1930

BOREN AVENUE

VBOB LLC | LMN | WEISMAN DESIGN GROUP
DESIGN REVIEW | SDCI PROJECT # 3031389-LU | FEBRUARY 19, 2018

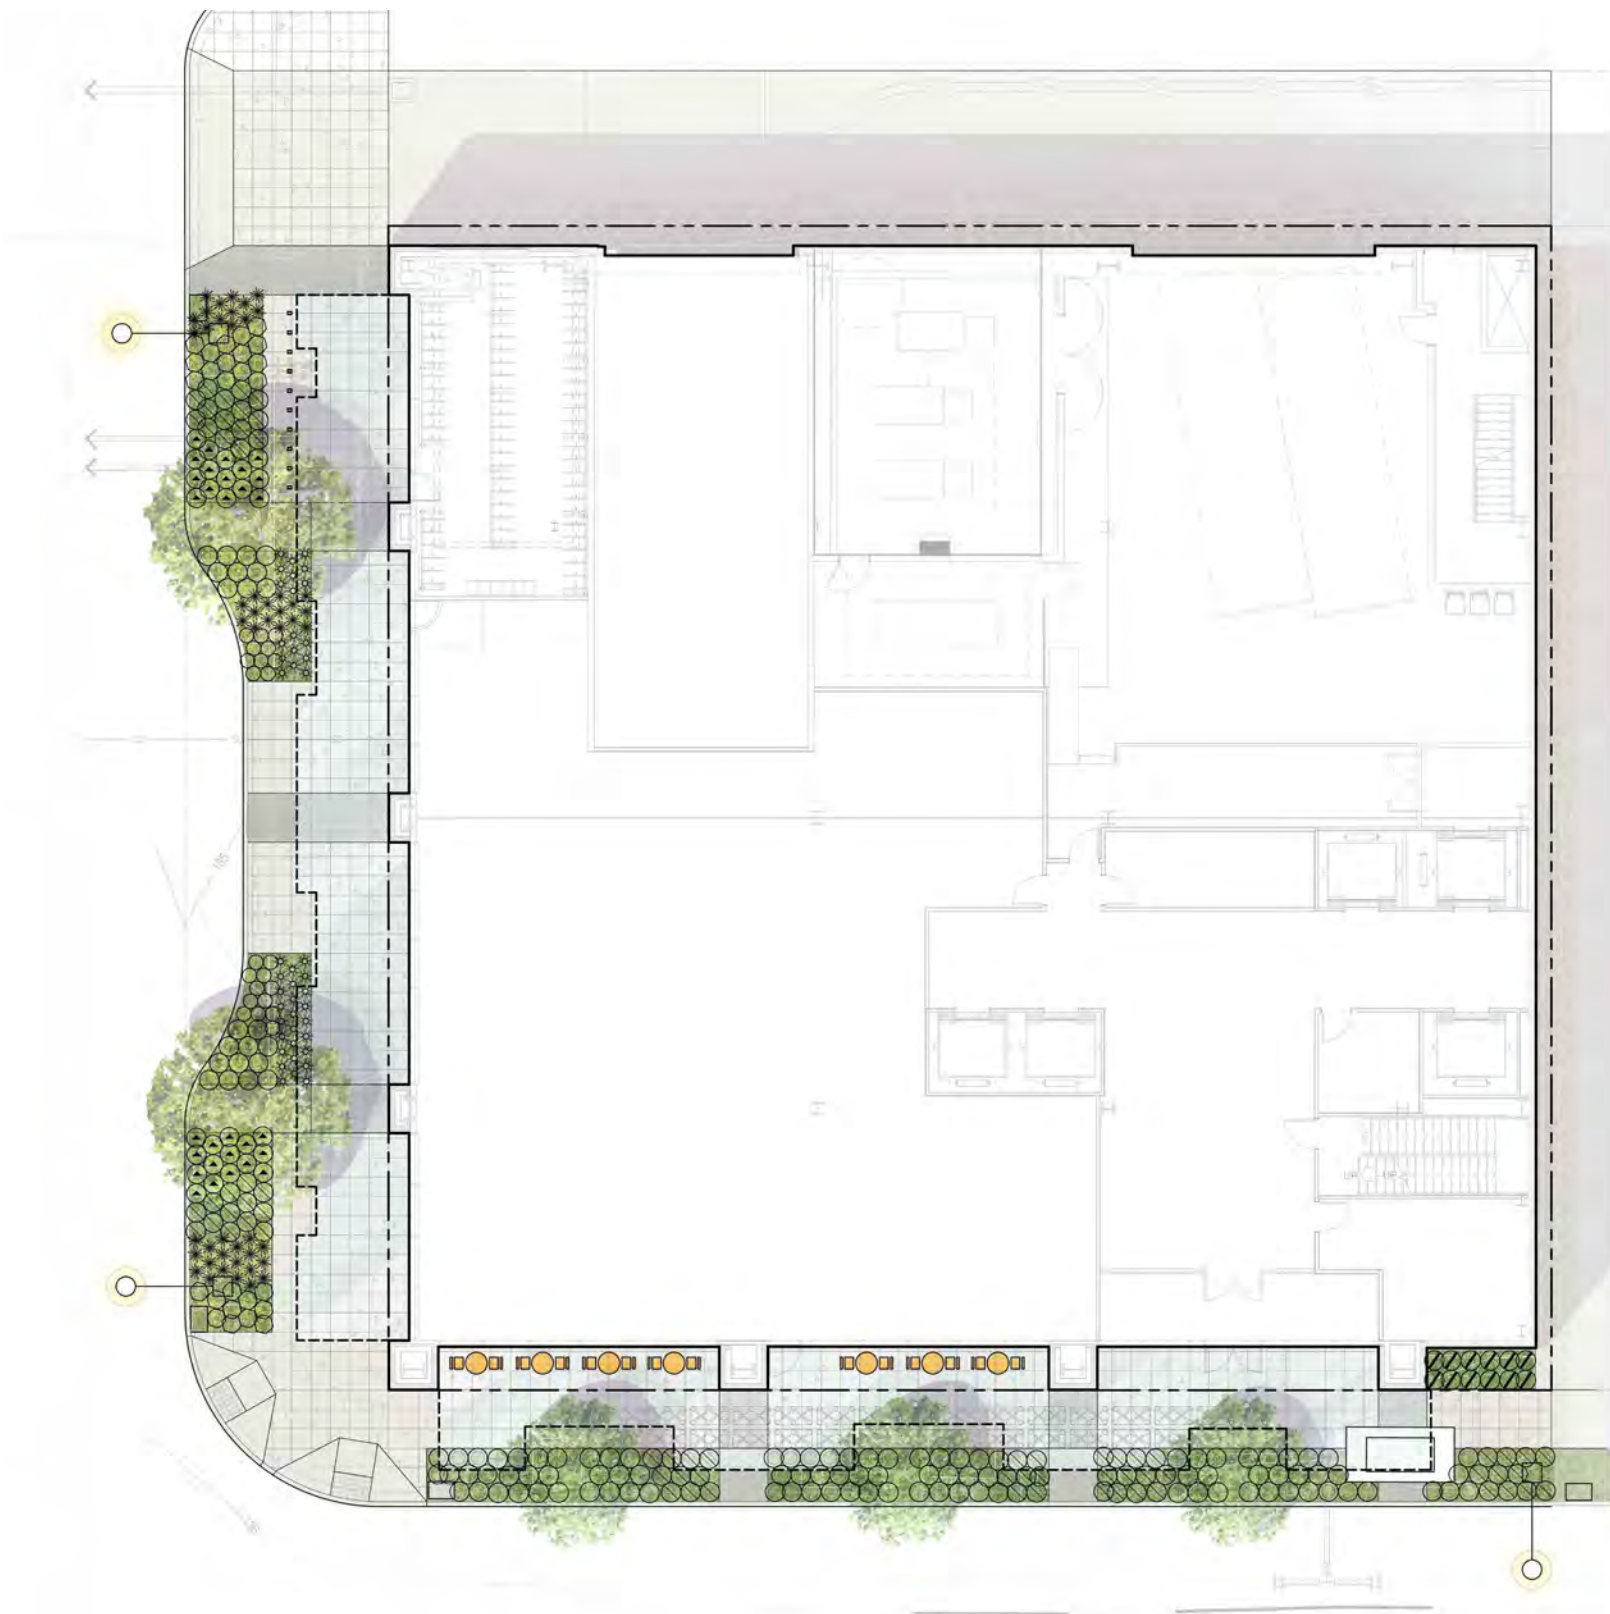
2B - The Board appreciated the streetscape design which continued the design language by carrying out the grid pattern onto the sidewalk with pavement treatment and landscaping locations. (D2 Enhance the Building with Landscaping)

The streetscape design remains the same with minor updates as further refinements are made.

ALLEY ELEVATION

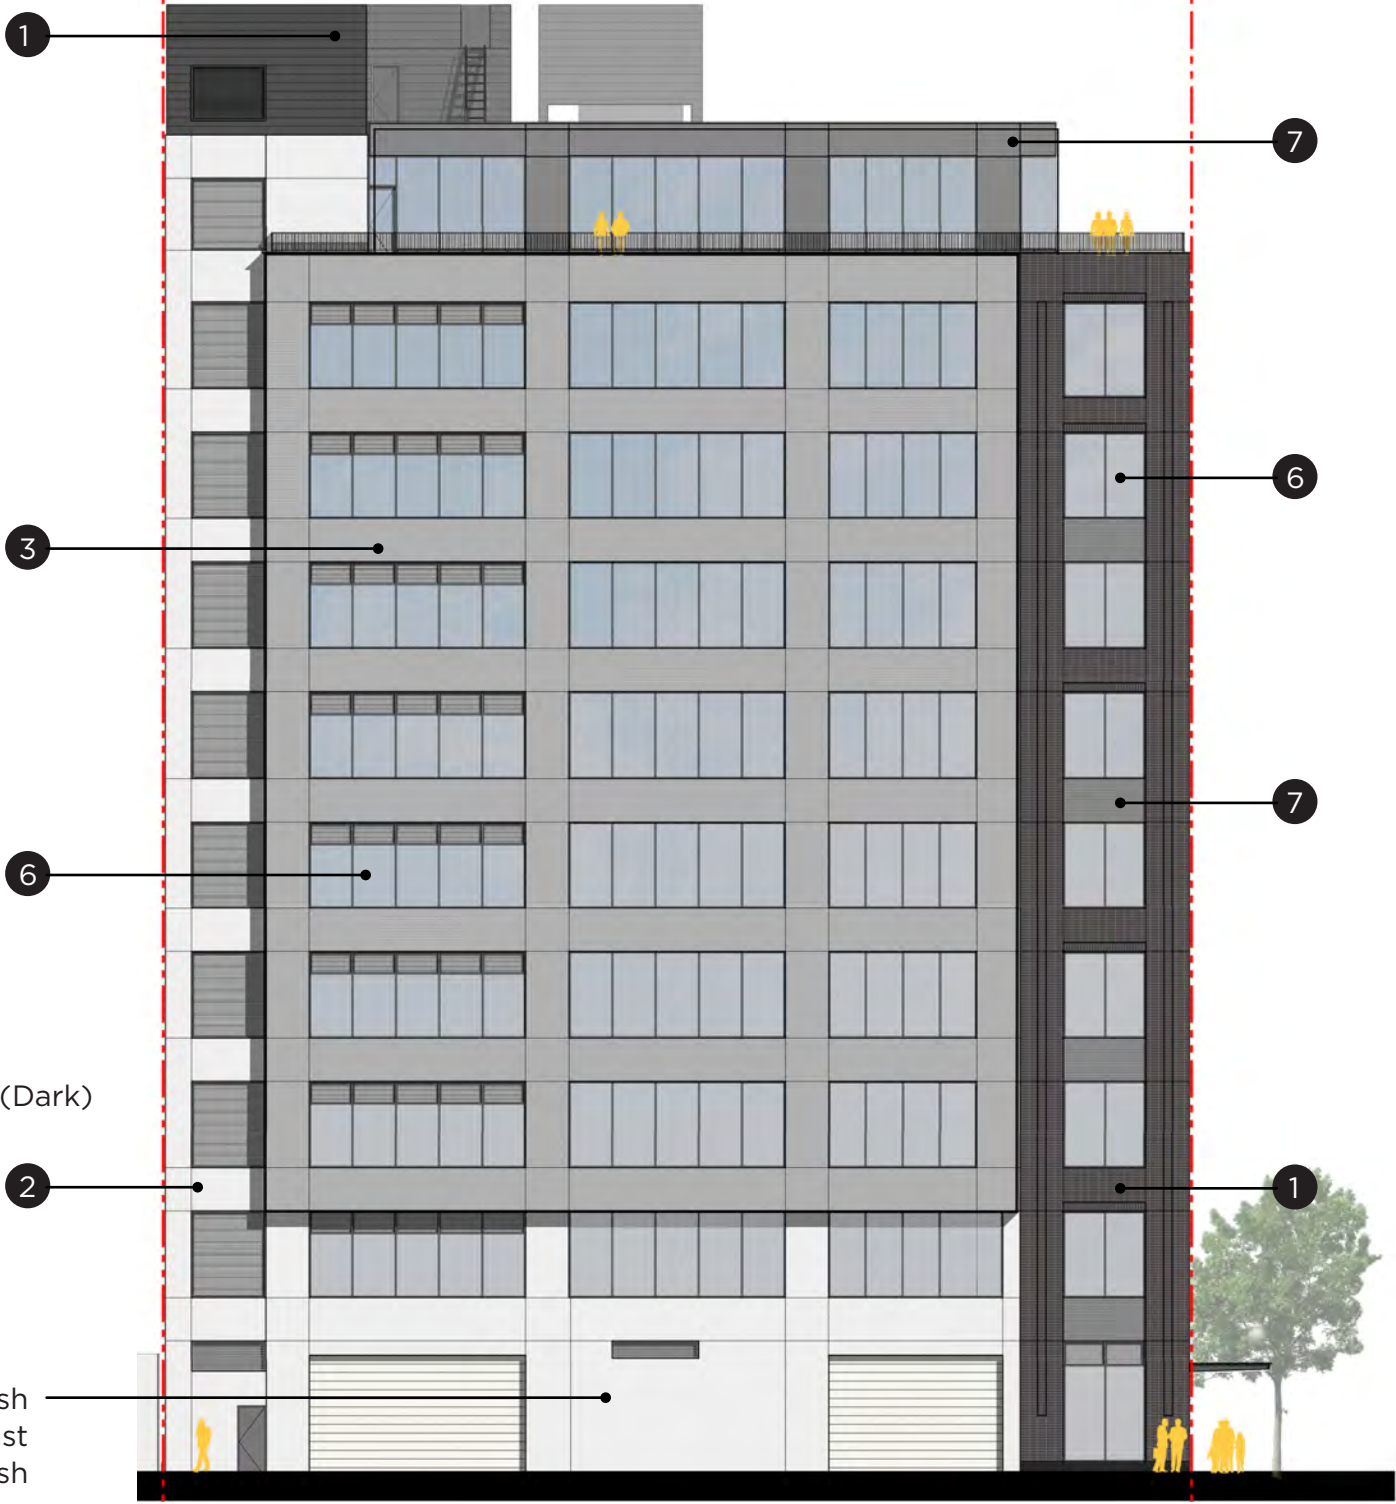
3A - Potentially carry the masonry language from Virginia Street to the alley base.
(C6 Develop the Alley Façade)

3B - At the next meeting clarify what type of masonry/CMU is proposed, as well as the mortar. (B4.3. Architectural Details)

To keep the purity of the brick massing form the brick along Virginia St. terminates after it turns the corner in the alley. CMU with a skim coat finish is proposed along the base of the alley facade to match the look and finish of the precast panels along the lot line facade. This material is easier to maintain along the Alley facade. The precast panels along the lot line facade turn the corner on the south side of the alley facade.

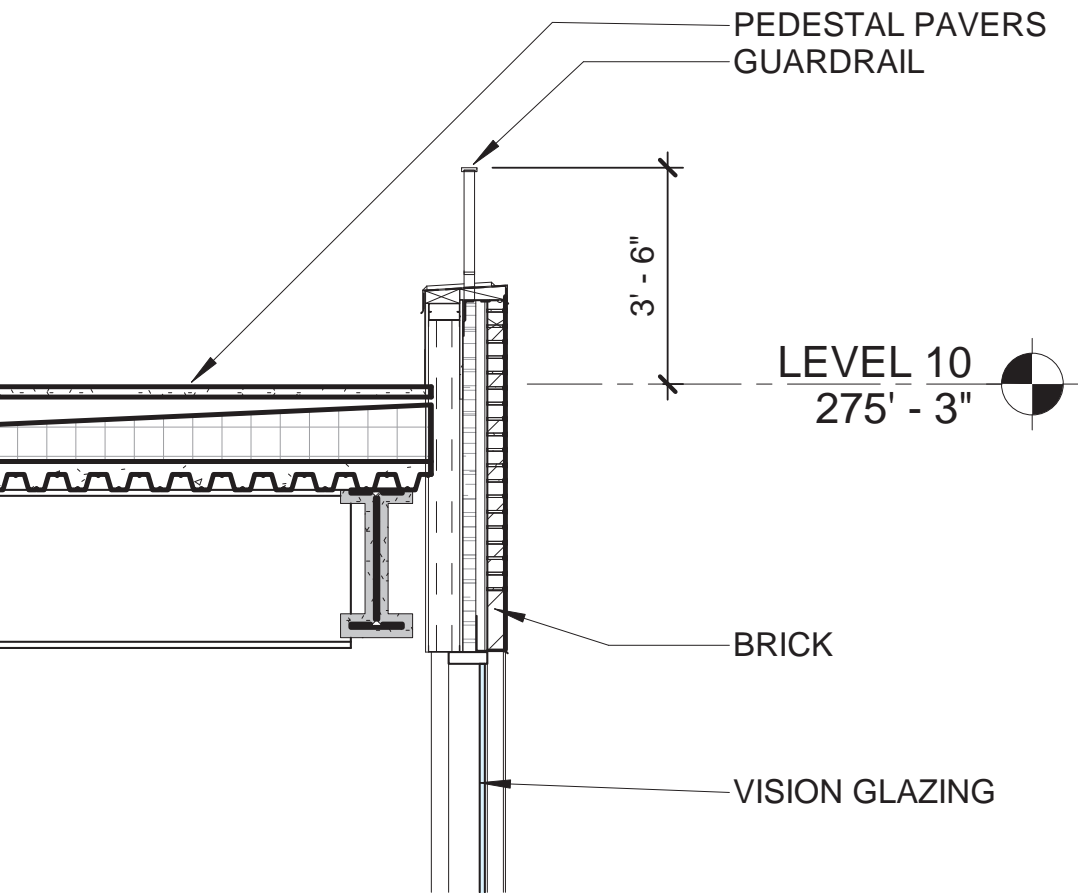
3D - Provide details related to the guardrail at the next meeting. (B4.3. Architectural Details)

A black metal picket railing is designed at the parapet of the level 10 roof deck.

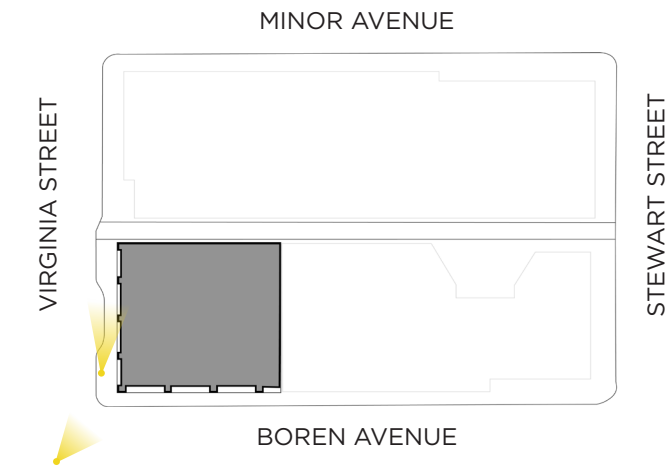
3E - Provide renderings illustrating the canopy details and varying widths. (B4.3. Architectural Details)

RESPONSE
Dark steel supports carry a translucent glass canopy. The canopy along Boren Avenue uses an asymmetrical break in the design to incorporate the required tree clearances. The canopy language turns the corner and continues along Virginia Street.

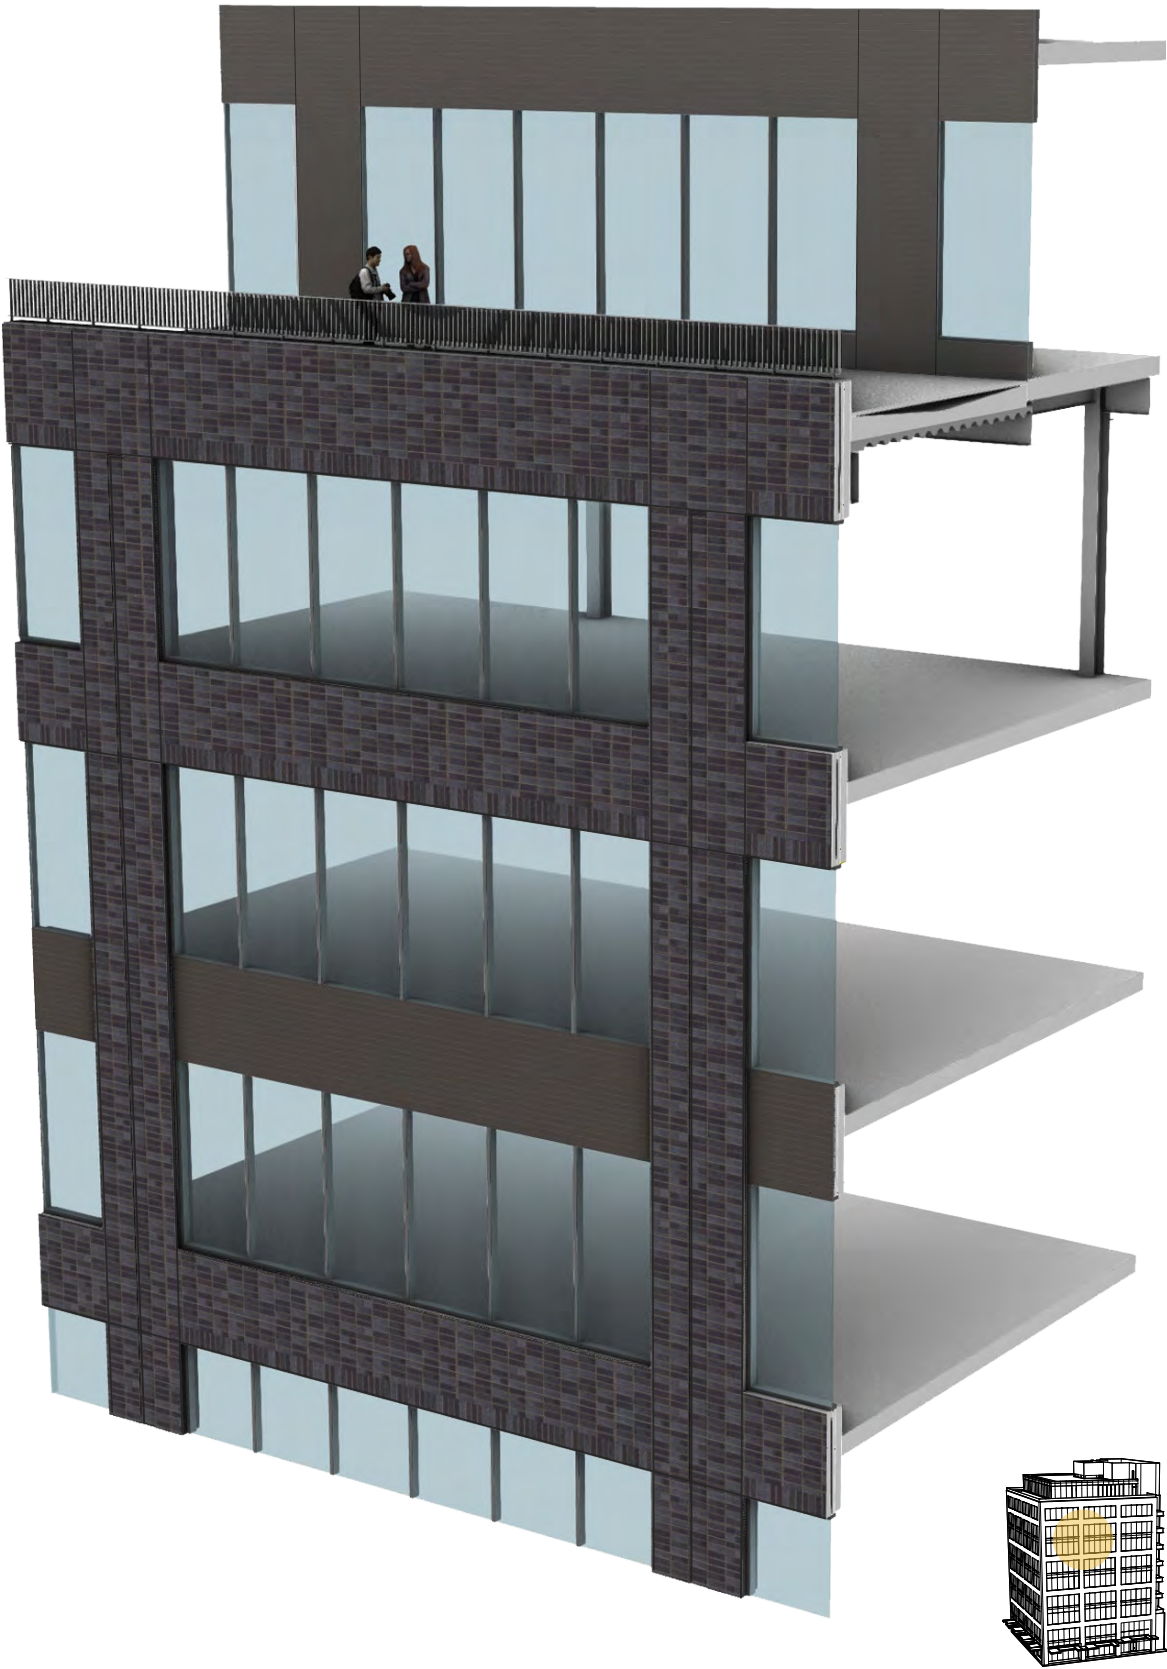
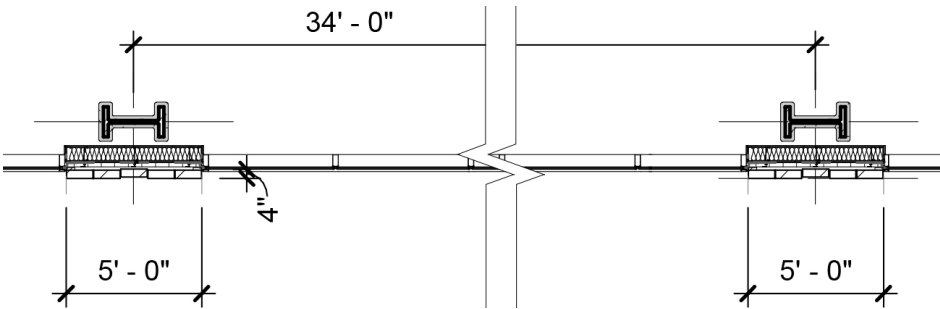
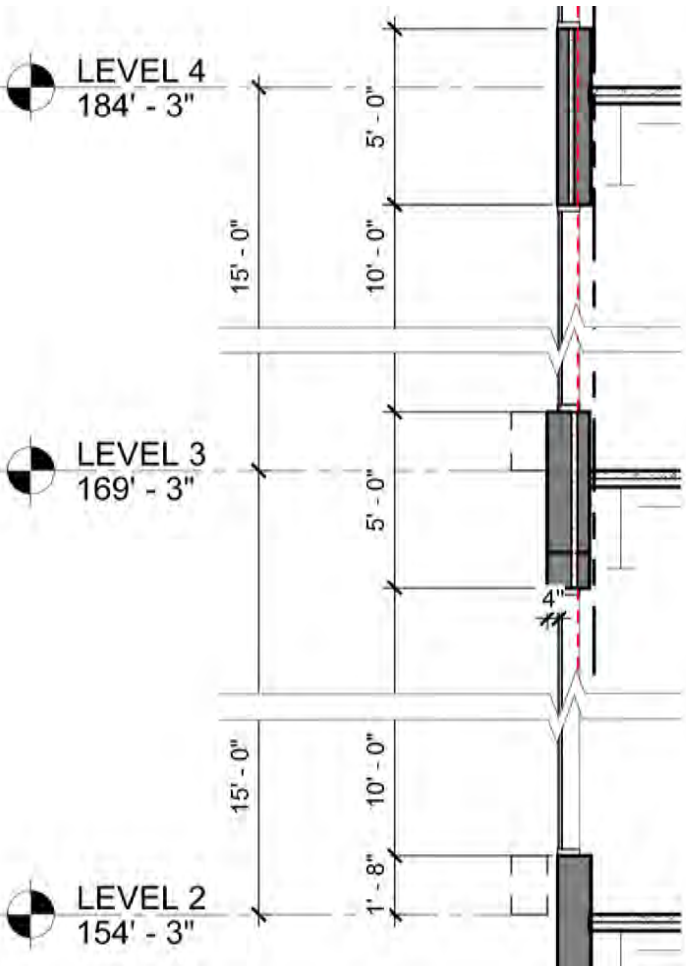
3F - Provide enlarged sections clarifying the depth and detailing from the frame to window system. (B4.3. Architectural Details)

The window bay has been recessed into the brick bay to provide depth to the facade.
